Mitigated Negative Declaration

Project No. 54384
SCH No. 2005091022

SUBJECT: PACIFIC COAST OFFICE BUILDING: SITE DEVELOPMENT PERMIT to construct an approximately 9,845 square-foot, two-story office building on a vacant 4.94-acre parcel. The project is located just east of the terminus of Scheidler Way, in the Mission Valley Planned District within the Mission Valley Community Planning area (Lot 1 of Nagel Tract Unit No. 2 Subdivision, Map 4737).

Pacific Coast Office Building
San Diego California

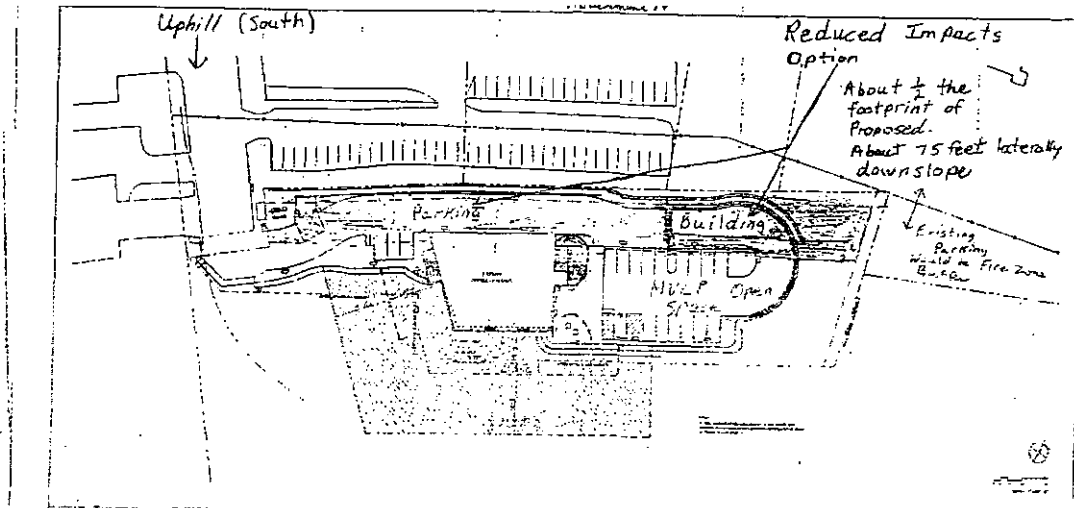
Stepped Retaining Walls
Highest Wall top at 160 Foot Elevation

2004 Plan

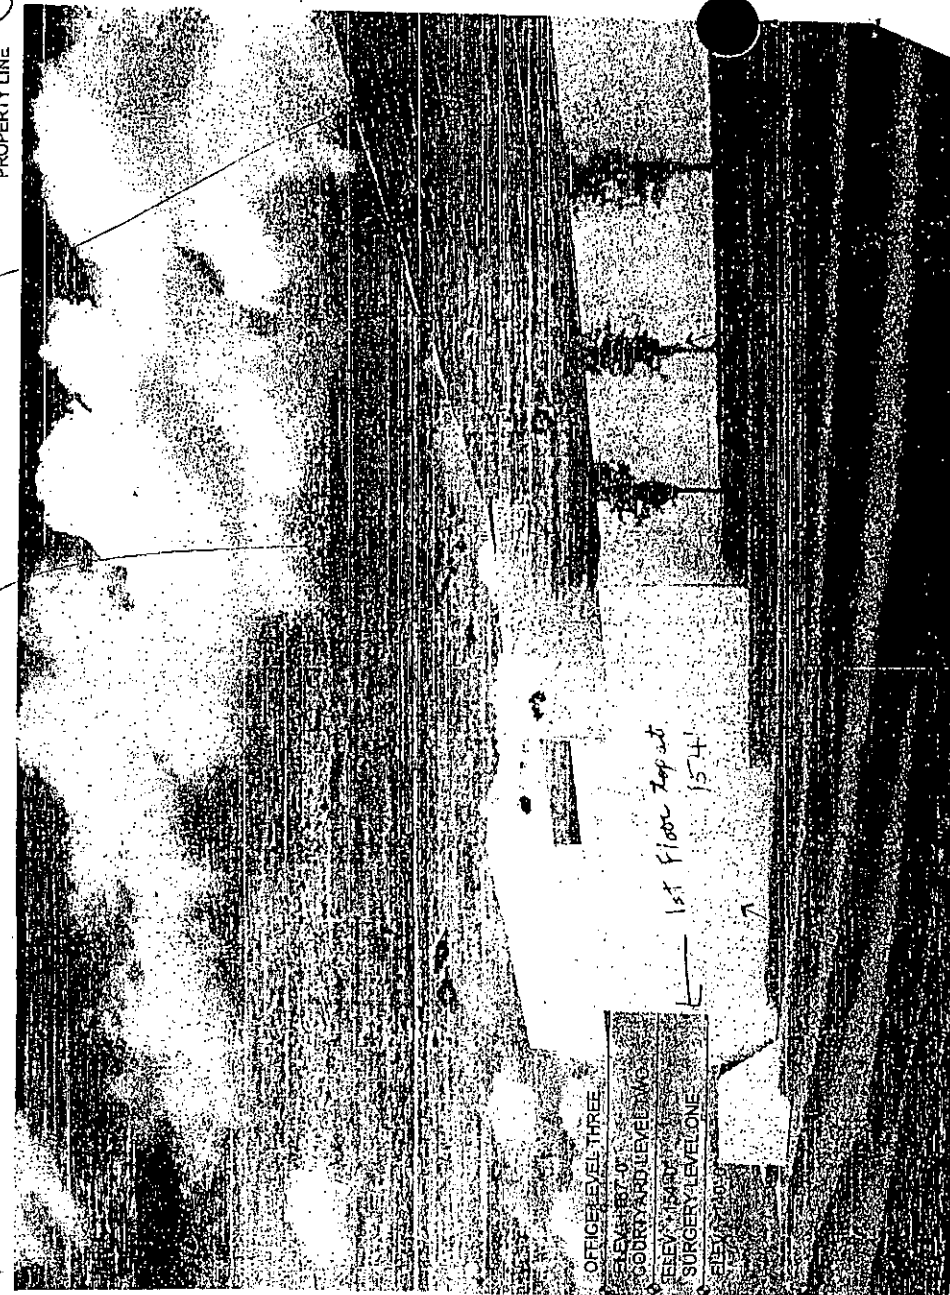
OPEN SPACE
EASEMENT
BEYOND TO
PROPERTY LINE
